Work Order ID 135270

Item Name: Quick Release Heli-Utility-Basket™ Long, HD Lid, Spacepod™/Squirrel Cheek Comp.

DART SERVICE INSTRUCTION

TO AMEND INSTALLATION INSTRUCTIONS D350-607-3 Rev.D,
INSTALLATION INSTRUCTIONS D350-607-4 Rev. C AND
INSTRUCTIONS FOR CONTINUED AIRWORTHINESS ICA-D350-607 REV. 6

FIGURE 1: INSTALLATION OF D4775-041 FWD STRUT

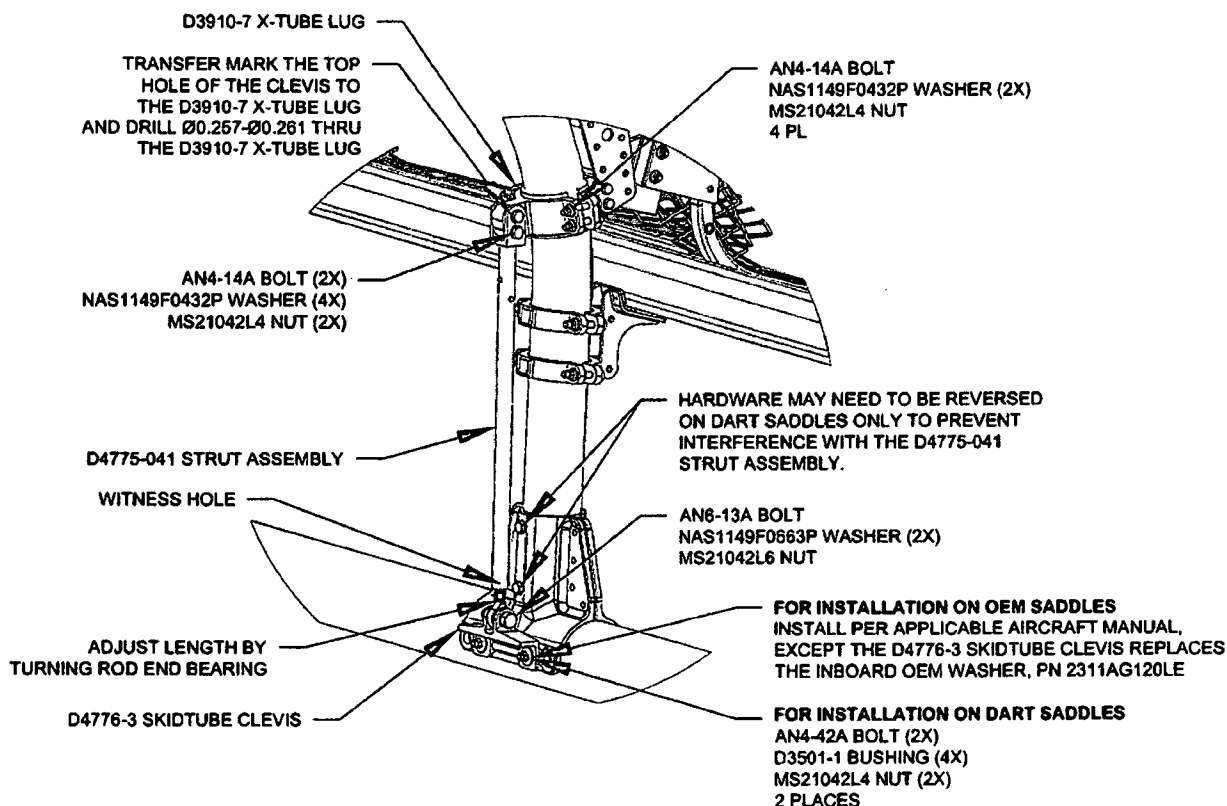
3.1 Substitute the Forward Lower D3910-5 X-Tube Lug with the D3910-7 X-Tube Lug as shown in Figure 1.

3.2 Install the forward D4775-041 Strut Assembly. Transfer mark from the upper hole on the clevis of the D4775-041 Strut Assembly to the D3910-7 X-tube Lug and drill thru the lug $\varnothing 0.257$ - $\varnothing 0.261$ as shown in Figure 1. Touch up chemical conversion coating per MIL-DTL-5541. Check the witness holes located at the bottom end of the D4775-041 Strut Assemblies to ensure that the thread from the rod end extends past the witness hole.
Torque MS21042L4/-4 nuts to 50-70 in-lbs (5.7-7.9 N-m). Torque MS21042L6/-6 nuts to 160-190 in-lbs (18.1-21.5 N-m).
